FIRST DRAFT MINUTES

March 20, 2014 Standards Committee Meeting

RE: Minutes from the March 20, 2014 Standards Committee Meeting

802-SNDH-02 SIGN PLACEMENT DIVIDED HIGHWAY INTERSECTION MEDIAN WIDTH > 30 FT (DRAFT)

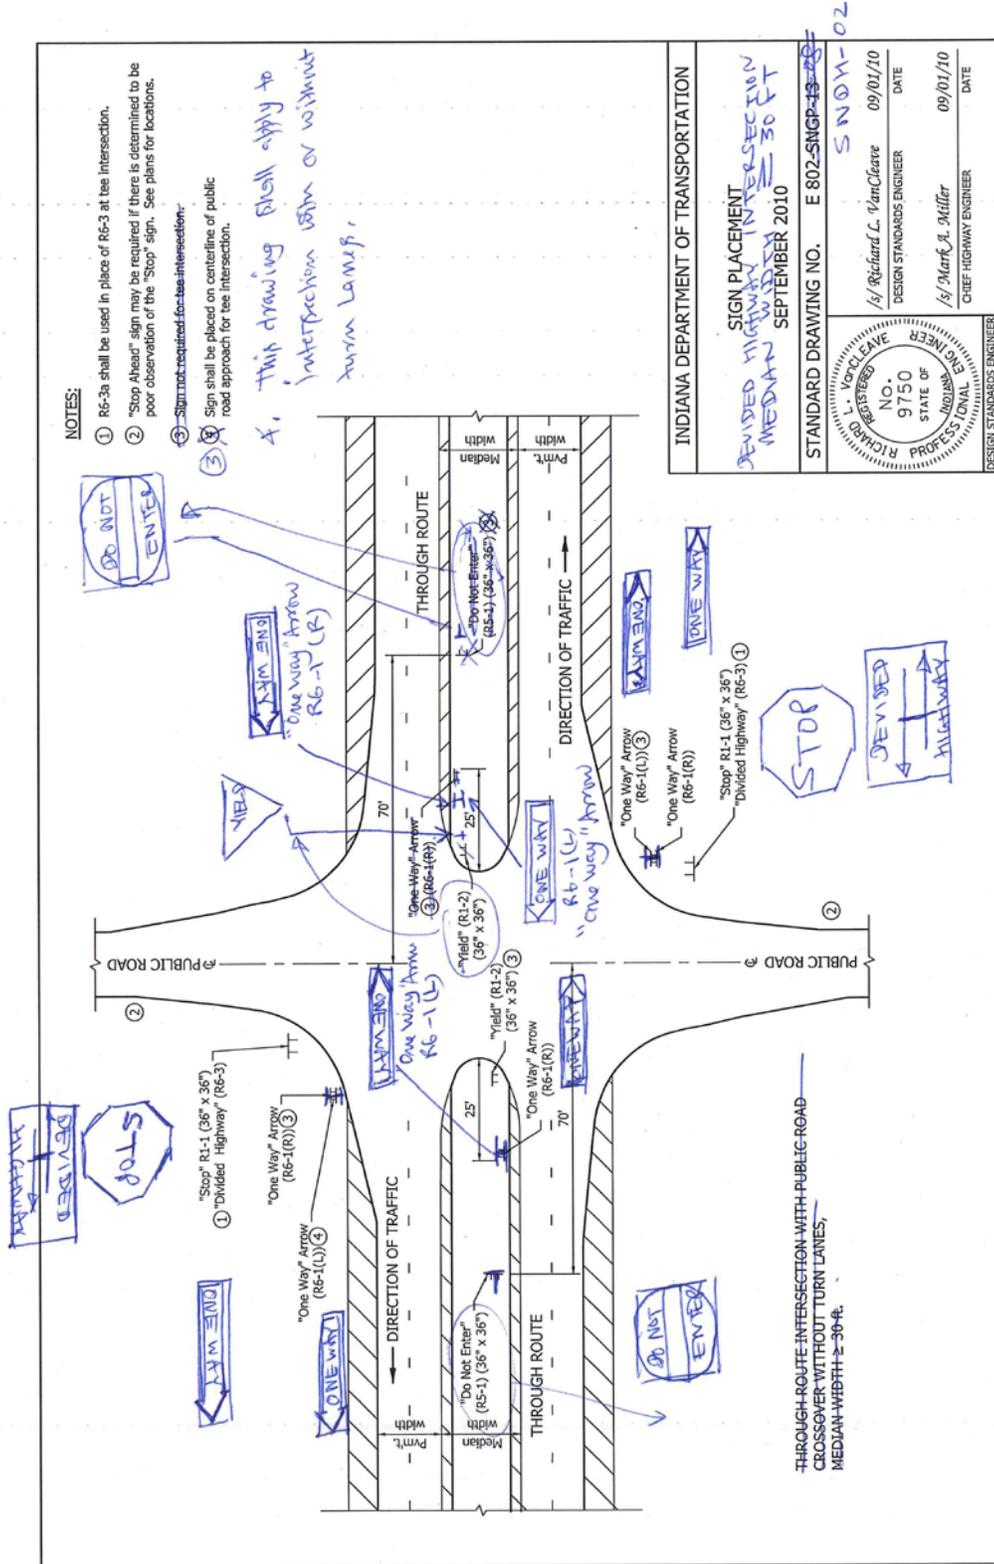
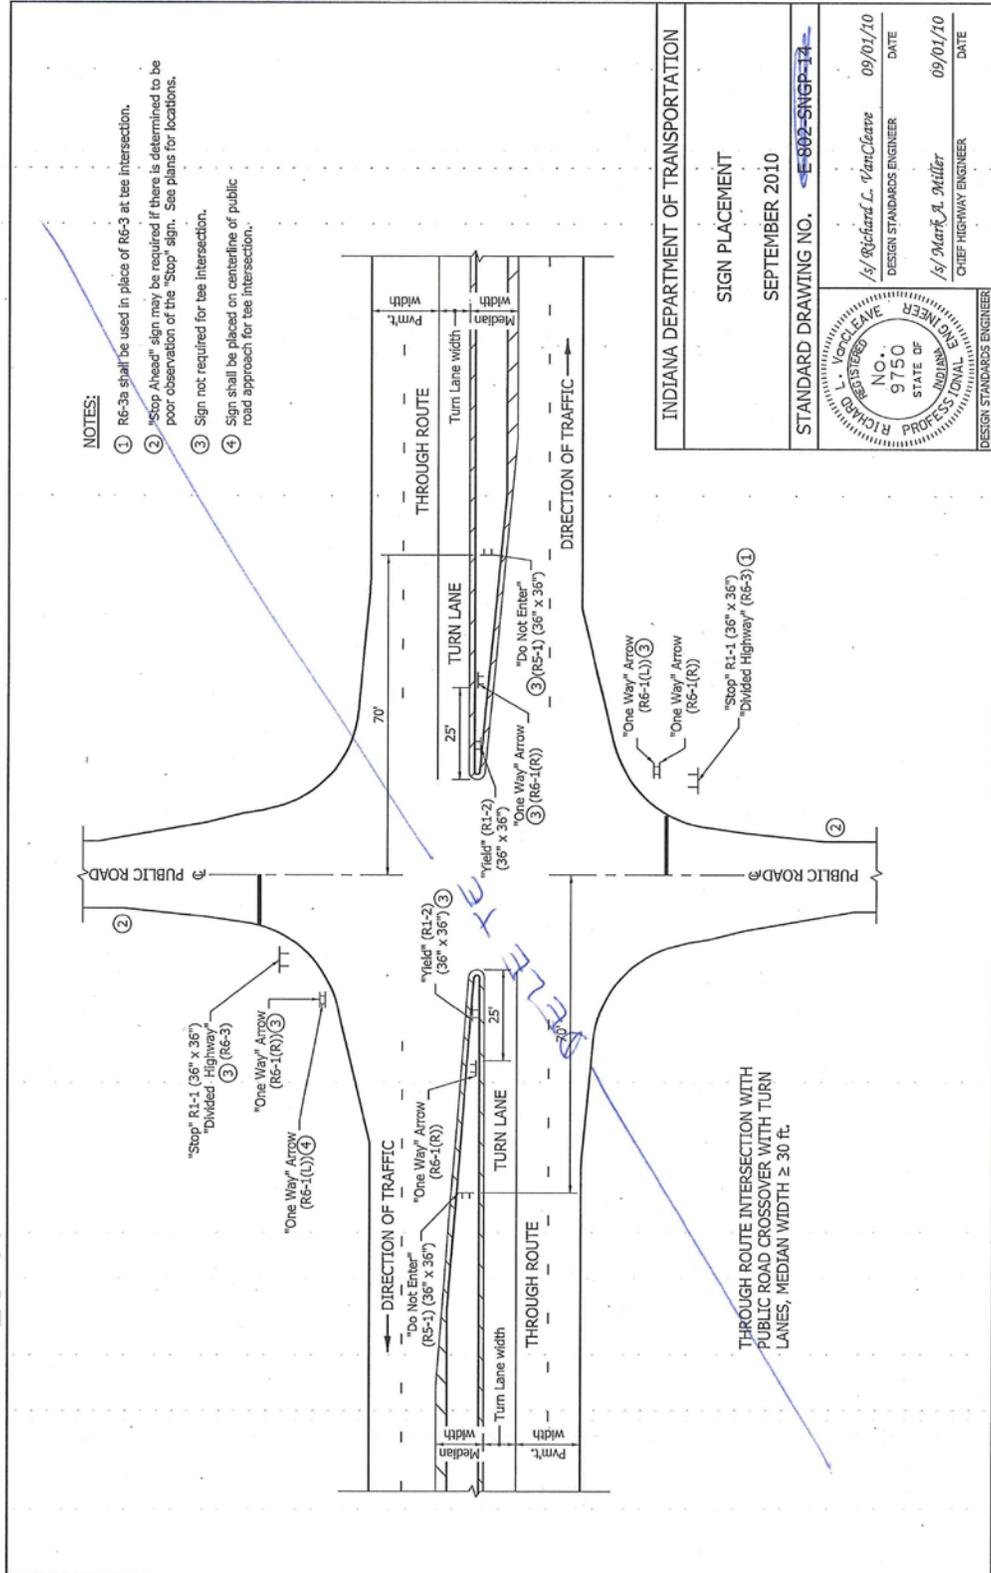
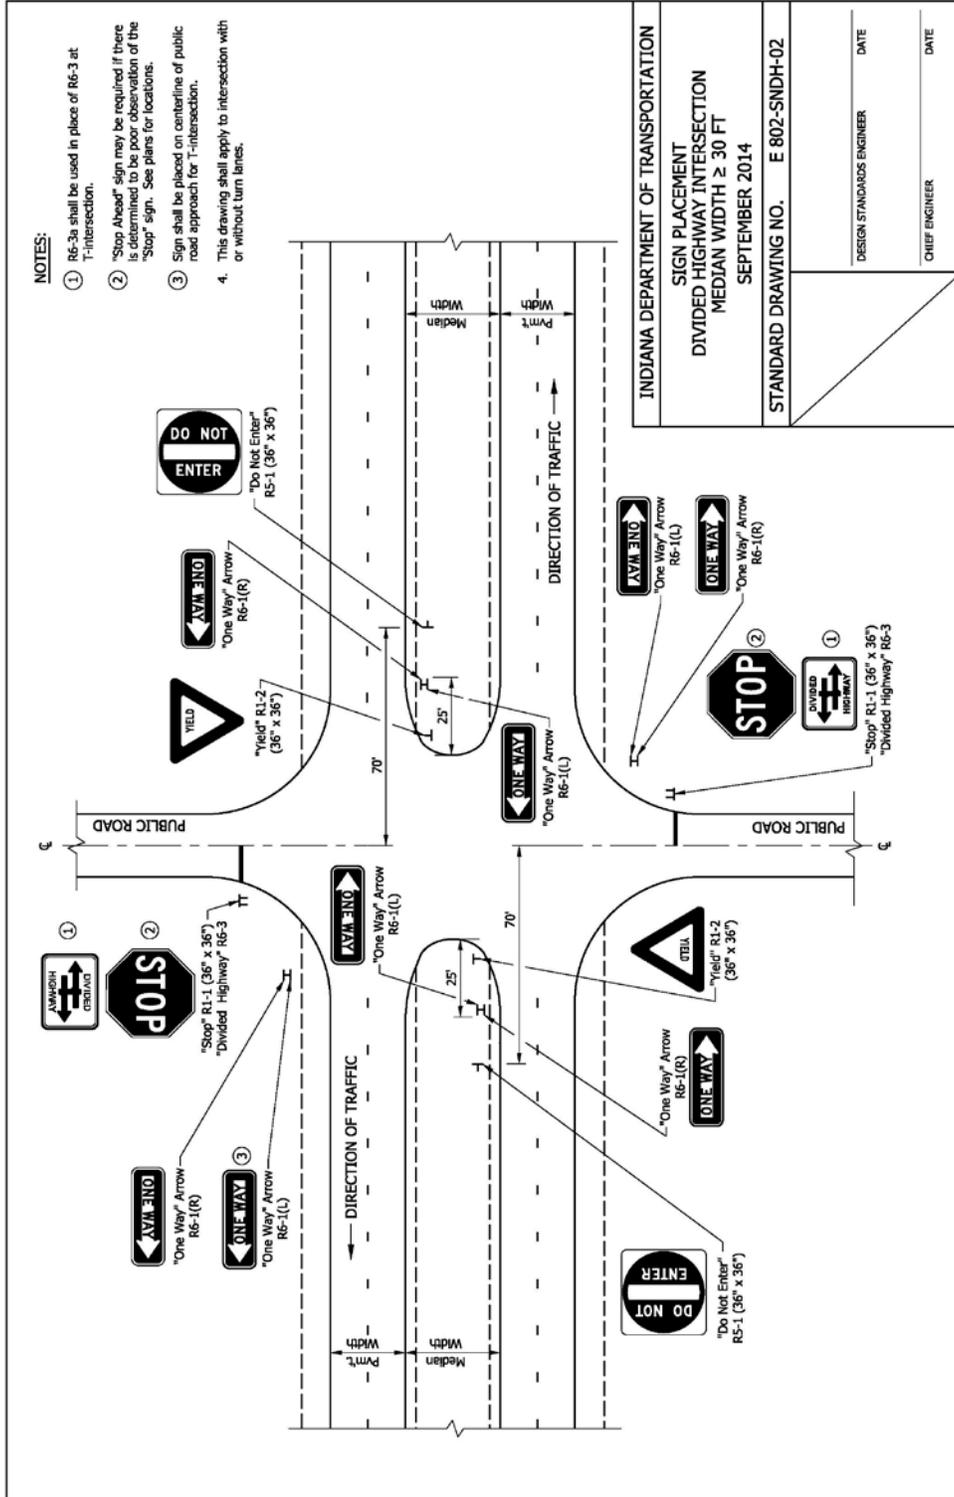
PROBLEM(S) ENCOUNTERED: Standard Drawings 802-SNGP-13 and 802-SNGP-14 showing Sign Placement for divided highway intersections with medians 30 ft or wider do not include the ONE WAY signs in the median that are required by the 2011 IMUTCD.

PROPOSED SOLUTION: Revise Standard Drawing 802-SNGP-13 and place in a new series, 802-SNDH. Also move 802-SNGP-11 into the new series and eliminate 802-SNGP-12 and 802-SNGP-14.
